**W-9: Upper Leon Creek and W-52 Culebra Creek Capacity Relief
Contractor Outreach Meeting
ADDENDUM 2
March 7, 2024**

CHANGES TO THE W-52 90% DRAFT PLANS

REVISIONS	
	W-52 CULEBRA CREEK SEWER CAPACITY RELIEF MH 12 AND MH 15 INVERT DETAILS

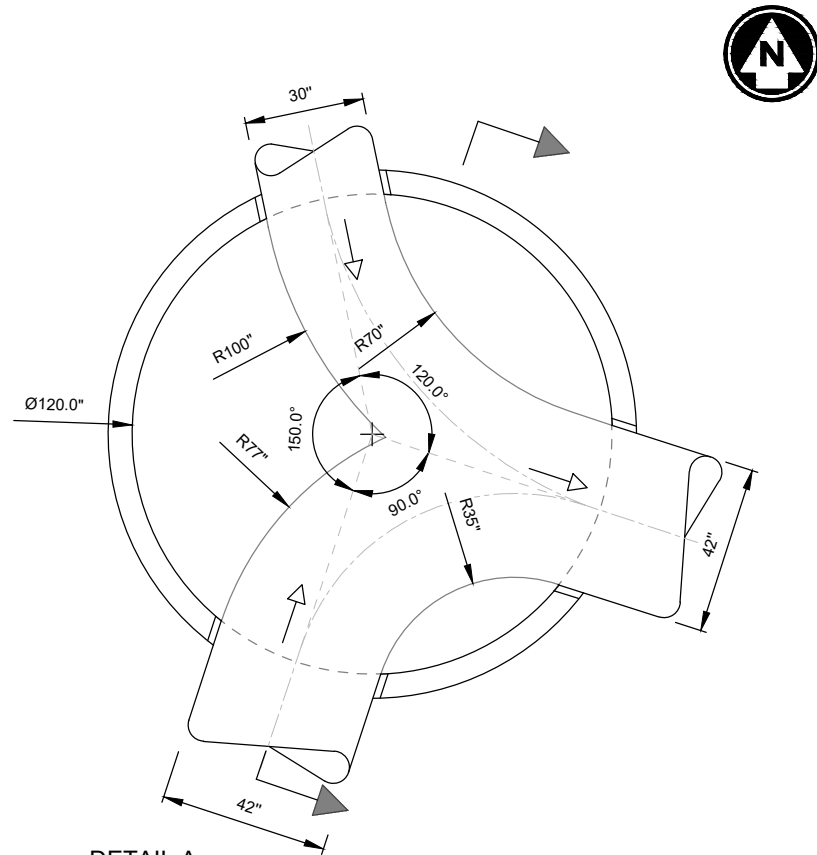
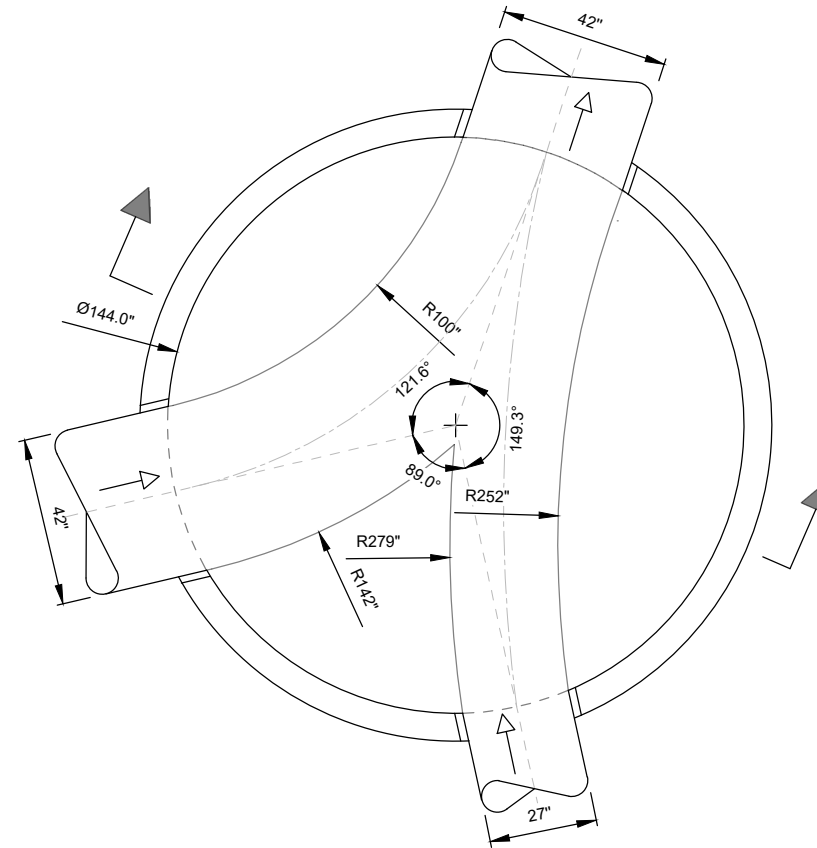
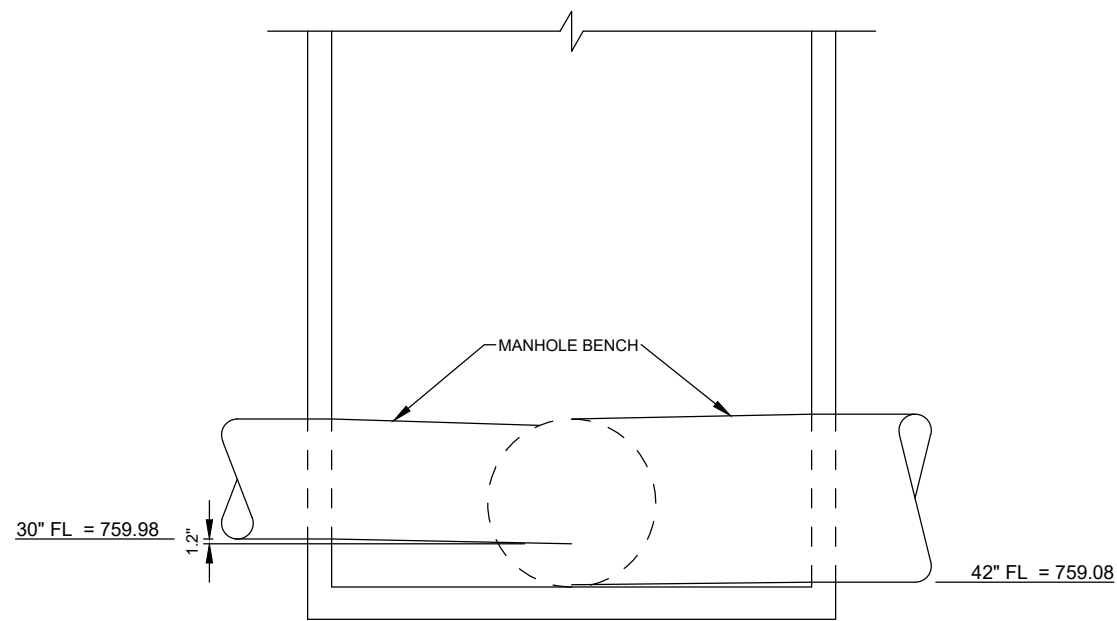
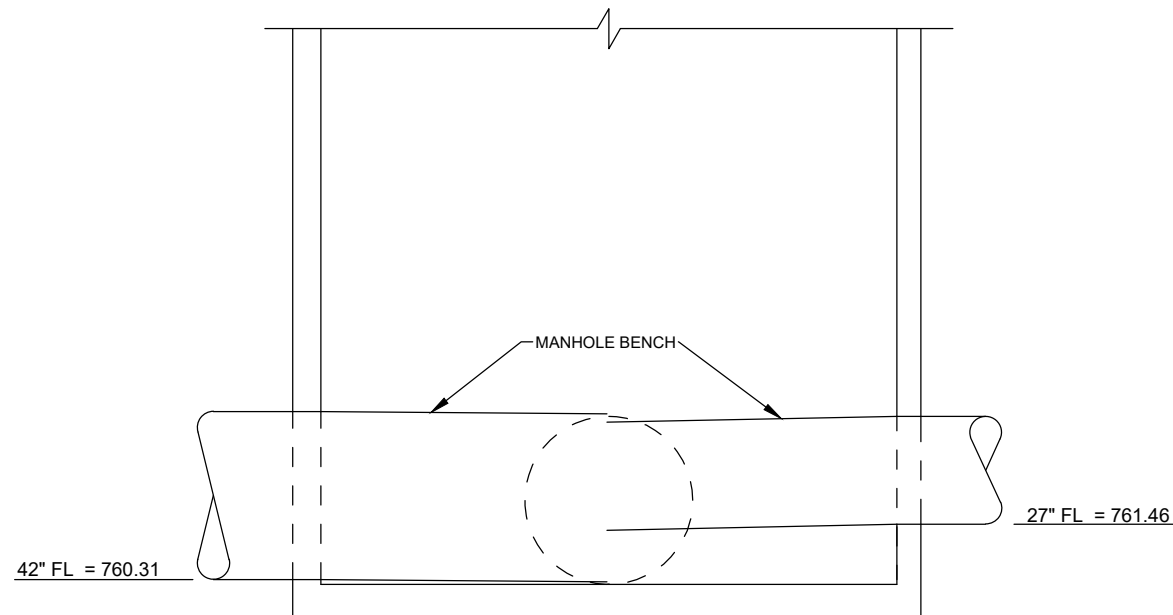
Response: Fiberglass manholes are under evaluation for these structures. The design at Grissom Road and for the drop manholes has been revised to replace the Vortex units. Please see the updated plan sheets attached to this addendum.
